# Certificate of Appropriateness

### 2000 W. Wisconsin Avenue

### Pabst Mansion

2/26/2025; [Reissued with change in mortar specification 9/2/2025. See original COA for drawings unrelated to mortar](#)

Photograph from 8/28/2025 showing three mortar test patches. HPC staff and owner's rep agreed to the rightmost color.

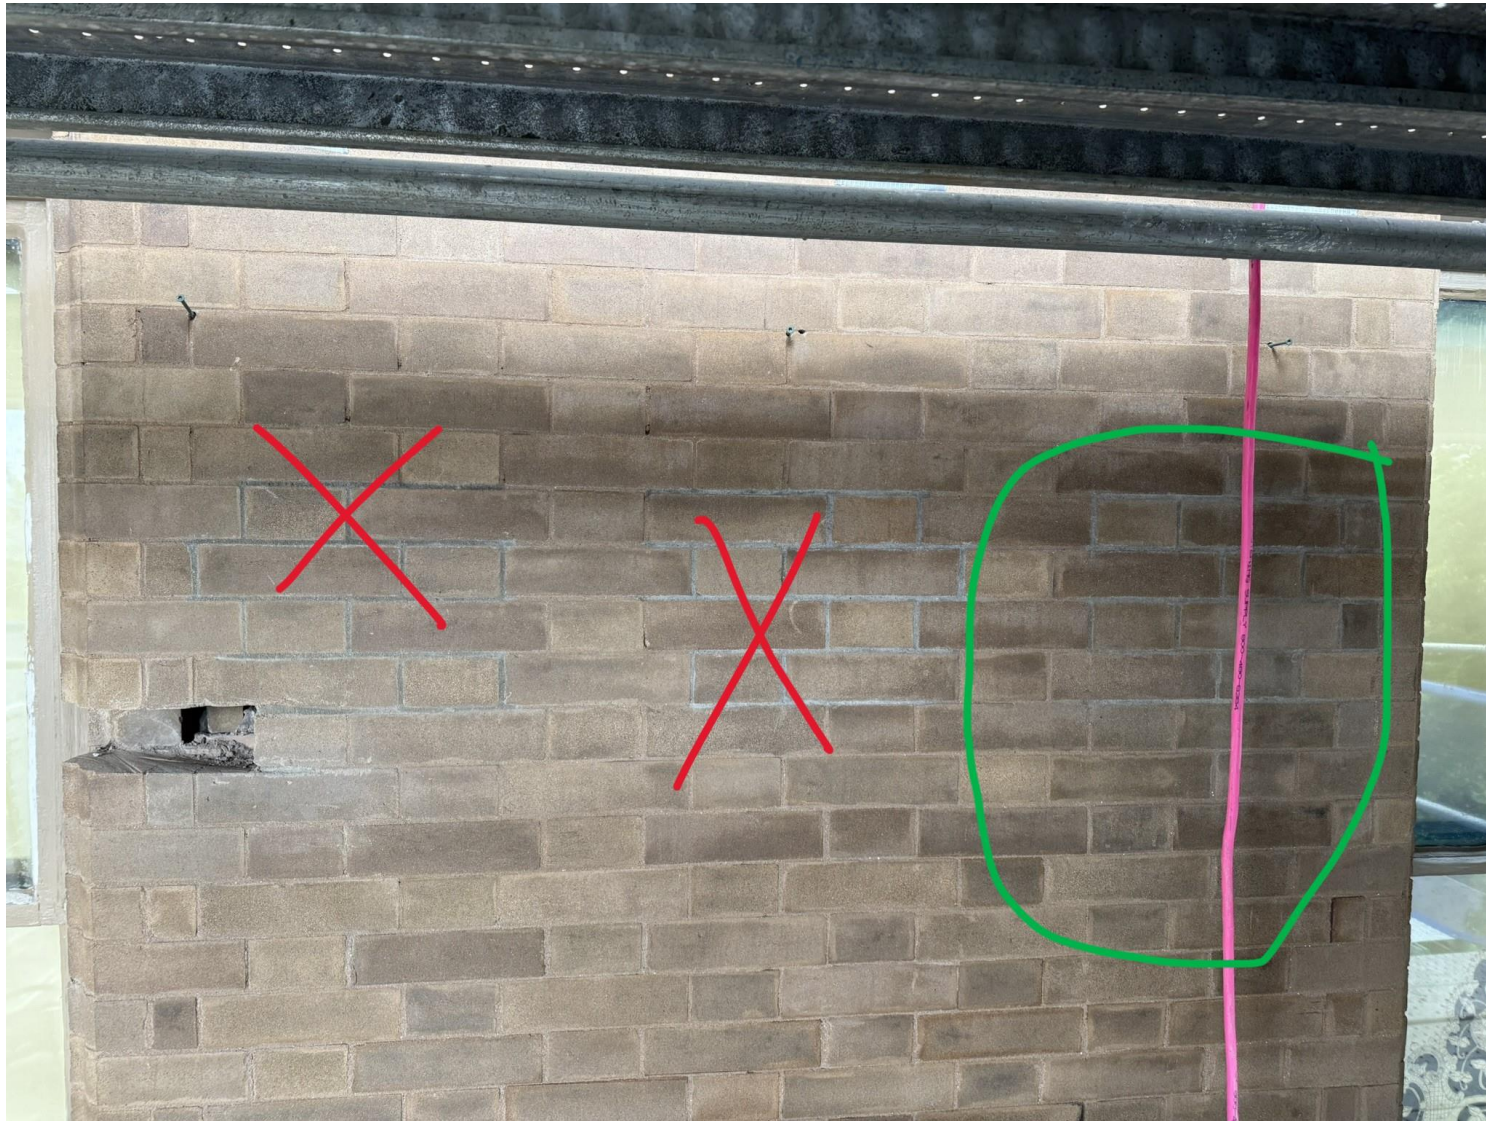
**Type N mortar (or anything harder) containing Portland cement shall not come into contact with historic brick. Further analysis has revealed that the purple mortar was used only the demolished carriage barn. The mansion itself had a medium to dark gray mortar with notable lime inclusions that are typically 1mm or less in diameter.**

New mortar must match the original mortar in terms of color, texture, grain size, joint width, and joint finish/profile. The compressive strength of the repointing mortar shall be equal or less than the compressive strength of the original mortar and surrounding brick or stone. The replacement mortar shall contain approximately the same ingredient proportions of the original mortar. Mortar that is too hard is subject to premature failure and could damage the masonry. See the city's books *As Good As New* or *Good for Business*, Masonry Chapters, for more information. In most cases, this means a lime mortar with natural hydraulic cement rather than Portland cement. No joint of a width less than 3/8" may be cleaned of damaged/decomposed mortar with power disc grinders. No over-cutting of the joints is permitted. Remove decomposed mortar back into the wall 2.5 times the height of the joint before repointing. When installing new flashing at a masonry feature, the flashing must be stepped or cut into the mortar joints. The bricks may not be cut to install flashing at an angle.

A sample panel of the masonry materials and their mortar must be reviewed and approved by HPC staff prior to general installation of the material. UNDER NO CIRCUMSTANCES SHALL UNPAINTED MASONRY BE PAINTED, BE GIVEN A WATERPROOFING TREATMENT, OR CLEANED BY ABRASIVE MEANS; THIS STATEMENT SUPERSEDES ANY OTHER WORDING IN THIS DOCUMENT INDICATING THE CONTRARY.
